UNITED STATES PATENT AND TRADEMARK OFFICE

APPLICATION NO.	FILING DATE	FIRST NAMED INVENTOR	ATTORNEY DOCKET NO.	CONFIRMATION NO.
10/555,816	11/07/2005	Robert Schegerin	41052/321928	2669

Office Action Summary	Application No. 10/555,816	Applicant(s) SCHEGERIN, ROBERT	
	Examiner Annette F. Dixon	Art Unit 3771

DETAILED ACTION

Exhibit A: Examiner modified Figure 3 of Stern (5,372,130)

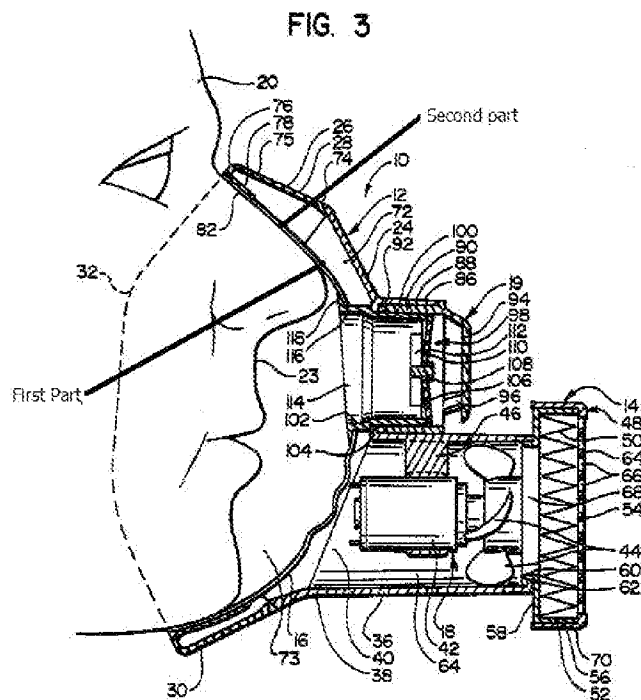
As to Claim 20, Stern discloses a respirator face mask (10) providing physiological protection, comprising: an oronasal face piece (24) which is connectable to a respiratory gas source (18), a semi flexible lip element (26) with an edge designed to position said oronasal face piece (24) on a user's face, and hygienic protection means (16) which are removably positioned (Column 6, Lines 15-17) at least partially inside said mask (10) and including a first part (Exhibit A) which provides hygienic protection and a second part (Exhibit A) which maintains said hygienic protection means in the mask, said second part cooperating with the semi-flexible lip element (26) and the face piece (24).

Yet, Stern does not expressly disclose the cooperation with the second part and the semi-flexible lip to be elastic. However, at the time the invention was made the use of

elastic cooperation with the second part and the semi-flexible lip was known.

Specifically, as the filter device (16) of Stern is capable of being removed from the mask (10) the filter device (16) may be replaced with any other device including but not limited to the device of Kaufman which includes a filter (1) in the first part of the filter and a seal (2) made of a plastic edge on the second part of the filter as Kaufman teaches a dual part filter medium for providing filtering to the first part and a sealing edge on the second part. The combination of these two references would result in the elastic connection of the second part and the sealing edge as both portions are made of plastic. (Figure 1, Column 2, Lines 40-63). Thus, it would have been obvious to one having ordinary skill in the art at the time the invention was made to modify the device of Stern to include a dual part filter medium as taught by Kaufman to provide additional sealing means of the mask to the user.
